PLANNING COMMISSION

AGENDA

**STAFF REPORT
DOWNTOWN OVERLAY DISTRICT REVIEW**

**CASE NO: OAR21-001
PROPERTY: 1376 3RD AVE**

1 LANDSCAPE PROPOSAL PLAN & EXTERIOR LIGHTING PROPOSAL PLAN (7)(b) (5)
A1.01 SCALE 1:100

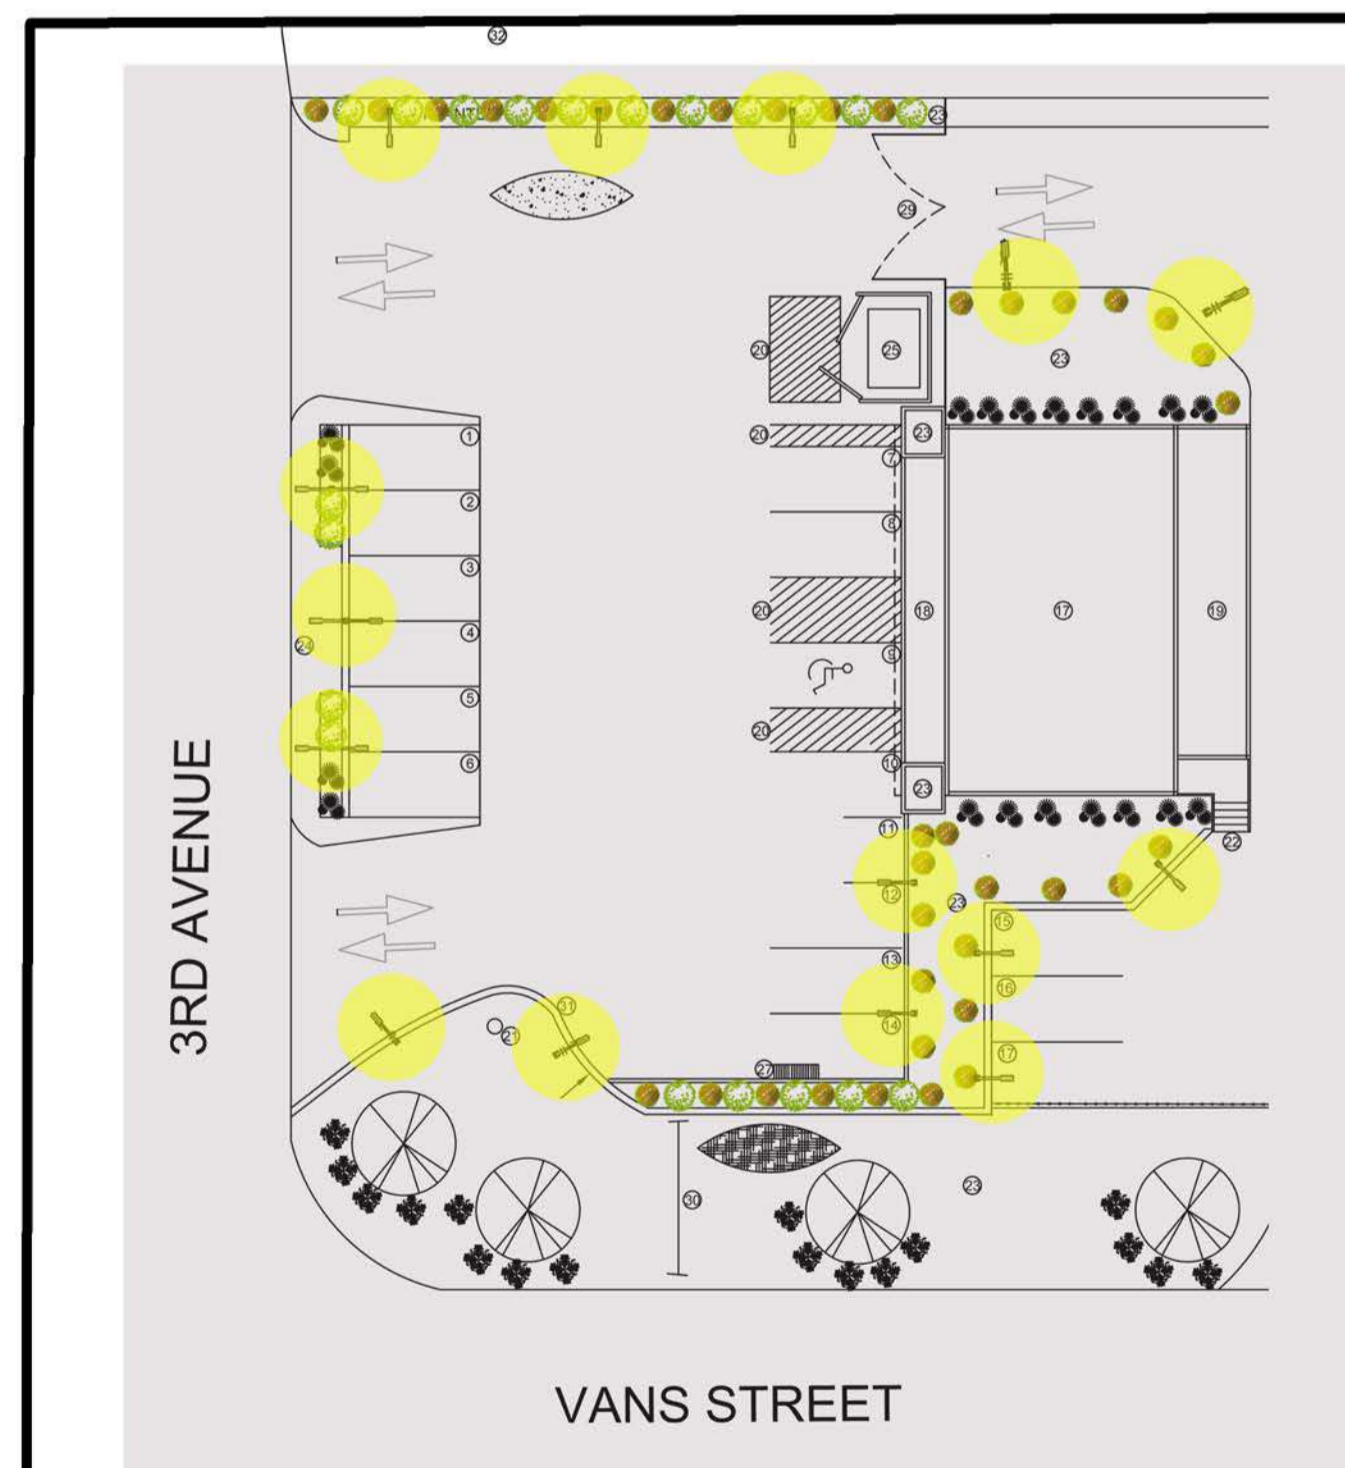
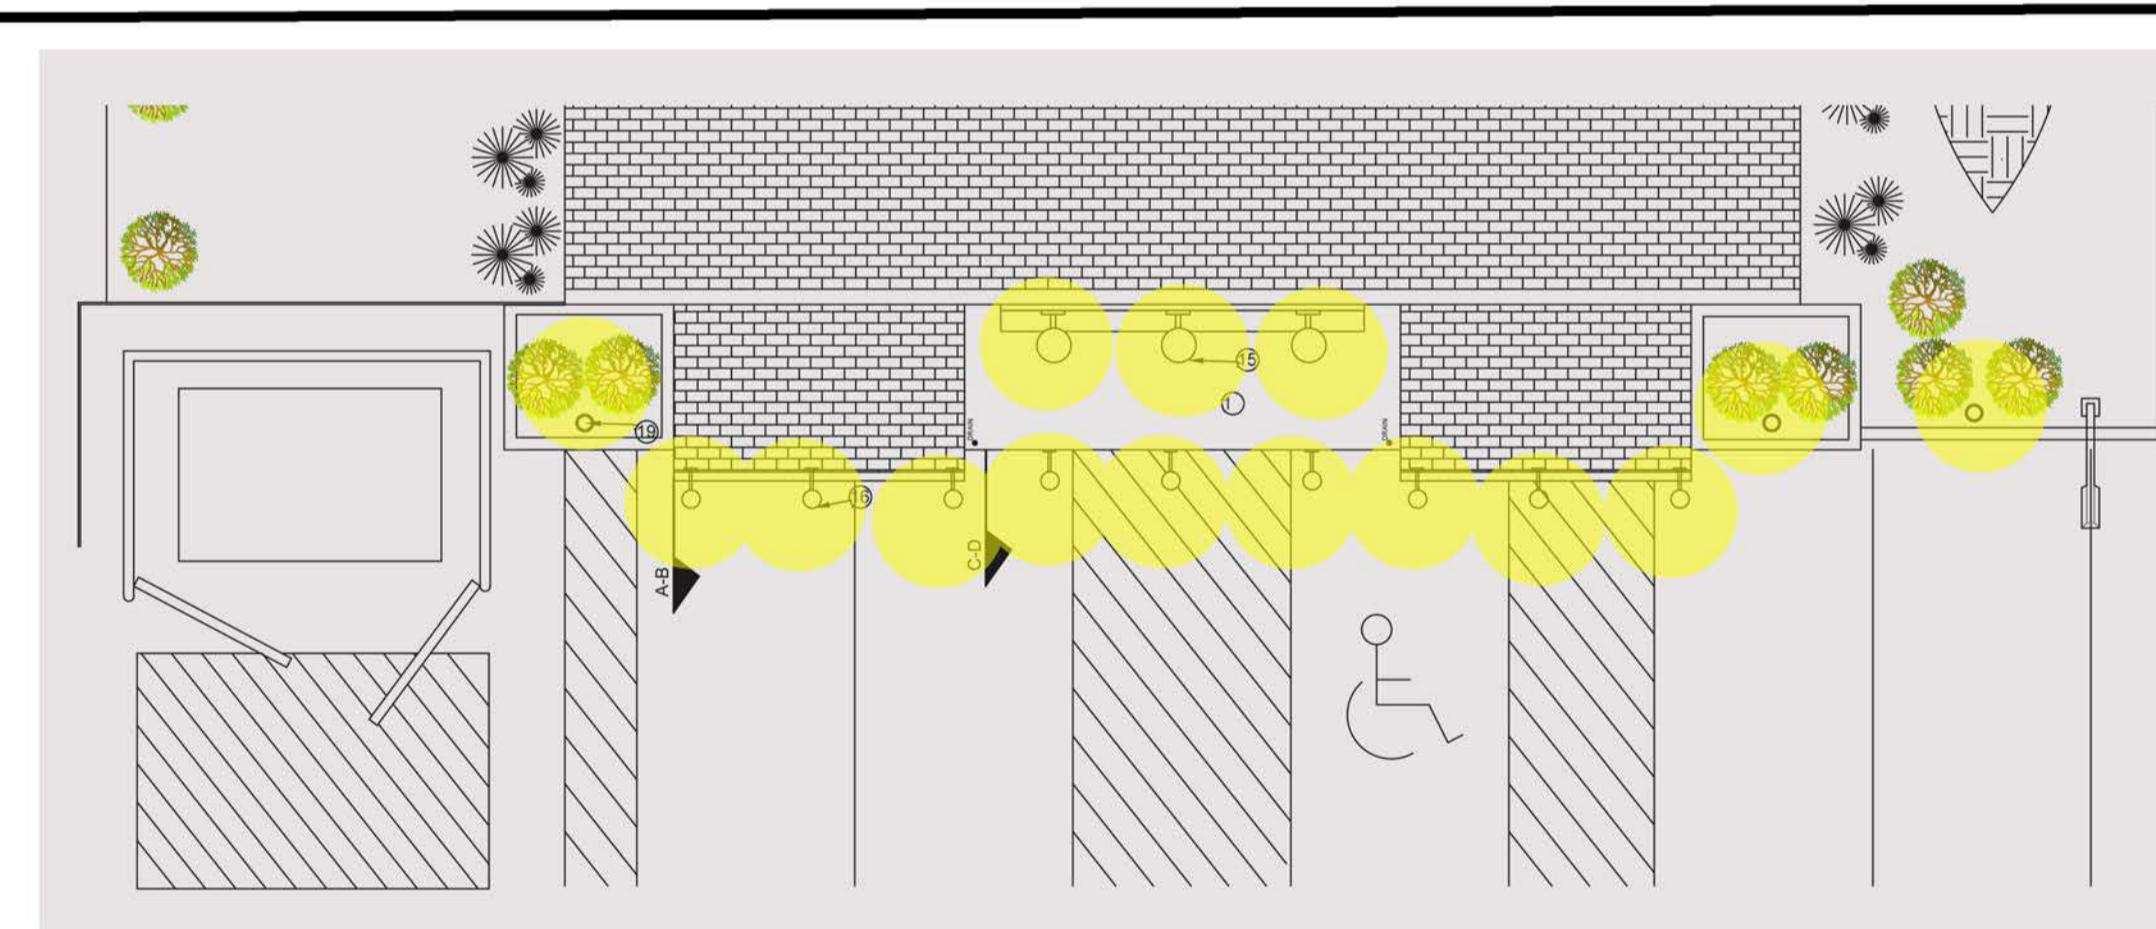
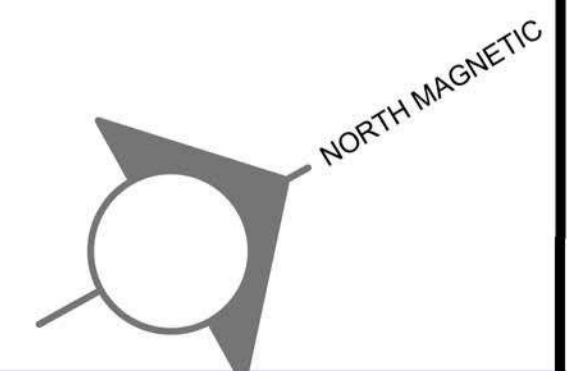
(3)(c)	Open areas shall be landscaped. Provide foundation plantings adjacent to the building.	No. No landscape plans were submitted.

(3)(d)	Sidewalks and parking areas shall be properly lighted to facilitate safe movement of pedestrians and vehicles.	No. No lighting plans were submitted.

(4) Awnings	n/a	A covered porch is proposed rather than awnings.
(5)	Exterior lighting must be placed and shielded so as to direct light onto the site and away from adjoining properties. Floodlights, wall pack units, other types of unshielded lights, and lights where the lens is visible outside of the light fixture shall be prohibited, except where historical-style lighting is used that is compatible with historic-style street lamps installed by the City. Neon lighting as accent lighting is prohibited.	No. No lighting details or plans were submitted
